Samtec Dual Row Headers ESQ/ESW Series

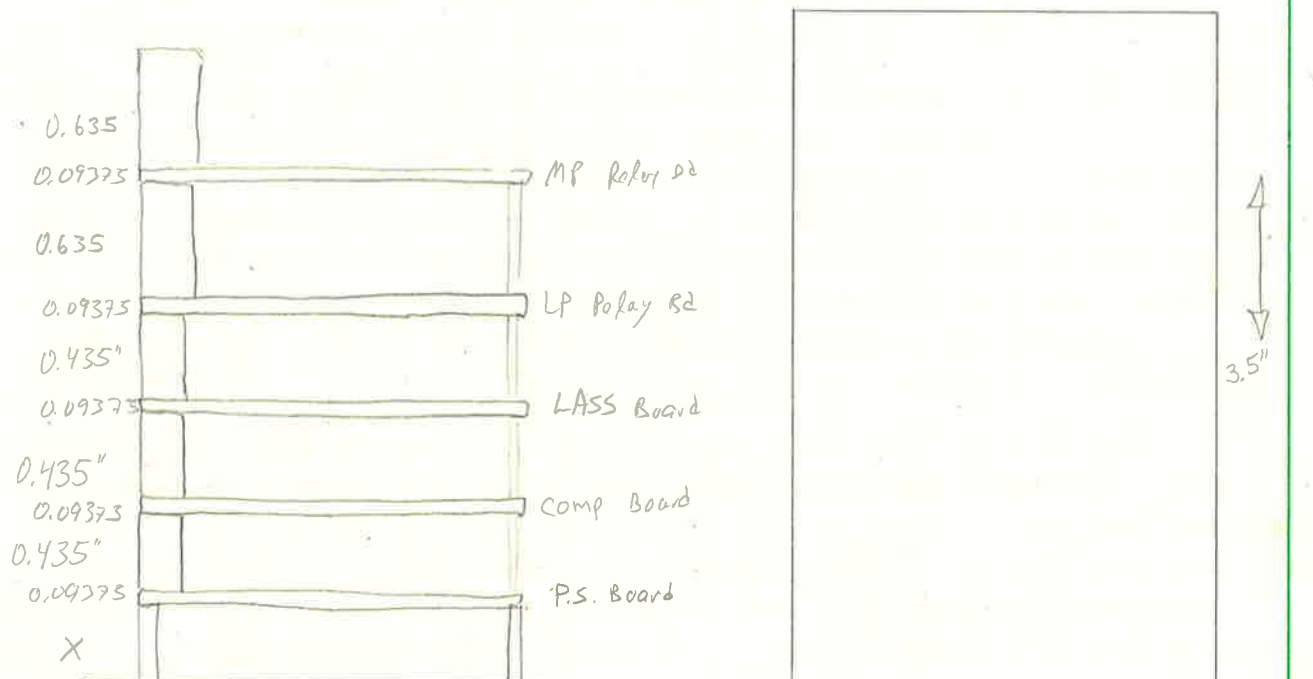
Minimum insulation (body) height is 0.435" (11.05 mm)

Post length 0.290" (7.37 mm)

~~0.480" (12.19 mm)~~ ← account for thickness of pcb? NO

$7/32" = 0.21875"$ ← Length of exposed bottom side posts on LP Relay Bd

LP & MP Relay Boards have $5/8" = 0.625"$ tall insulation (bodies)
